### ▲<sup>1</sup> ALLEGRO 1100/1300, MINI, 1100/1300

#### CLUTCH JUDDER

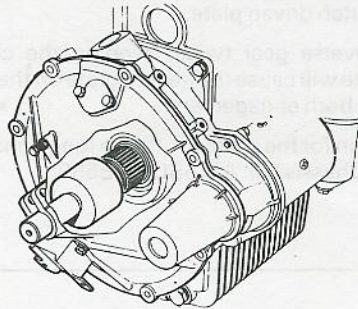
When investigating complaints of clutch judder it has been discovered that a possible cause is misalignment of the clutch cover. The following method of rectification is recommended.

1. Remove the clutch cover, clutch and flywheel assembly.
2. Remove the clutch release bearing and shaft and throw out arm from the clutch cover.
3. Slide the aligning tool 18G 1247 onto the end of the crankshaft and slide the cover onto the tool. (As shown in the diagram below.)

NOTE: If the clutch cover will not enter the register due to fouling at the point arrowed in diagram 'A', machine approximately 0.040" from that point.

4. Check to ensure the cover slides freely over the aligning tool into position without fouling. Refit at least four cover to flywheel housing bolts, equally spaced to hold the cover in position.
5. Drill two holes  $\frac{1}{8}$ " diameter through the cover and housing at 180° to each other and  $\frac{3}{16}$ " from the edge of the cover.

6. Remove the clutch cover and aligning tool.
7. Replace the clutch and flywheel assembly ensuring that the driven plate linings and primary gear oil seal are in good serviceable condition.
8. Reassemble the clutch cover and replace using two roll pins ( $\frac{1}{8}$ " x  $\frac{1}{4}$ "). If the roll pins are not available, use two pieces of  $\frac{1}{8}$ " dia. brazing rod as dowels. (these must be a snug fit in the holes to ensure correct alignment) then tighten the cover to flywheel housing bolts. (See Fig. B.)
